Work Order ID 92511

Item Name: Plate

ENGINEERING CHANGE NOTICE NO.		02937		SHEET 1 OF 1	
DWG NO. 647.1700	REV: NC	PREPARED BY J. JACKSON	DATE: 07/14/10	EFFECT ON DWG <input type="checkbox"/> INC. <input checked="" type="checkbox"/> UNINC.	
DWG TITLE: SKID DEFLECTOR ASSY					
APPROVED BY: ENGR <i>[Signature]</i>	MFG <i>[Signature]</i>	QC <i>[Signature]</i>	EFF: CURRENT ORDER		
REASON: REVISED F/N 8 AND NOTE 3. ADDED INSPECTION DIMENSIONS TO DRAWING VIEWS.

SHEET 2,
ZONE A1 IS:

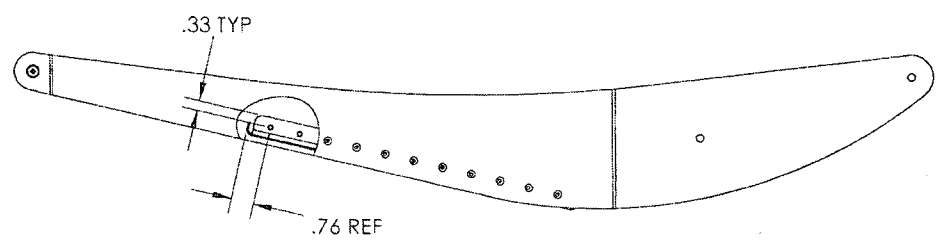
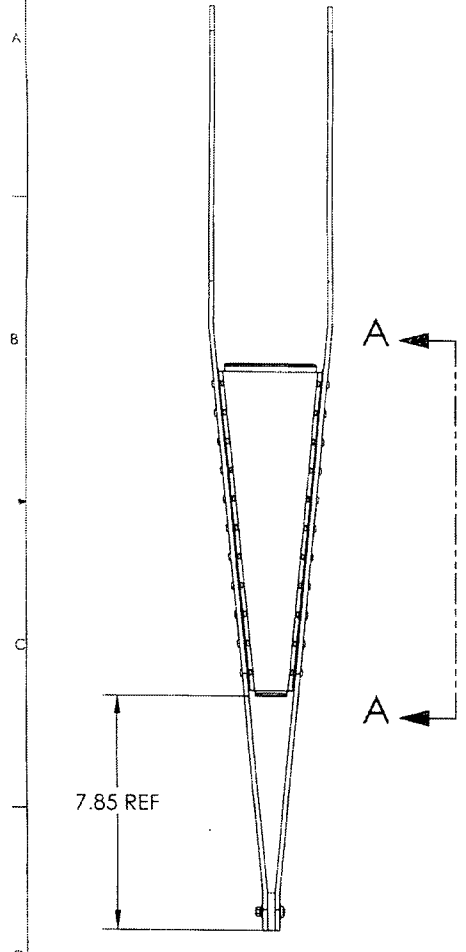
8	R	601.1622	1	SCREW	MS27039-1-14 /
F/N	TC	PART NUMBER	QTY	DESCRIPTION	MATERIAL/SPECIFICATION
DOCUMENTS EFFECTED:					DER REVIEW REQUIRED
<input type="checkbox"/> MDL <input type="checkbox"/> INSTALL INSTRUC <input type="checkbox"/> FMS <input type="checkbox"/> ICA <input checked="" type="checkbox"/> BOM					<input type="checkbox"/> MAJOR <input checked="" type="checkbox"/> MINOR
					<input type="checkbox"/> YES <input checked="" type="checkbox"/> NO
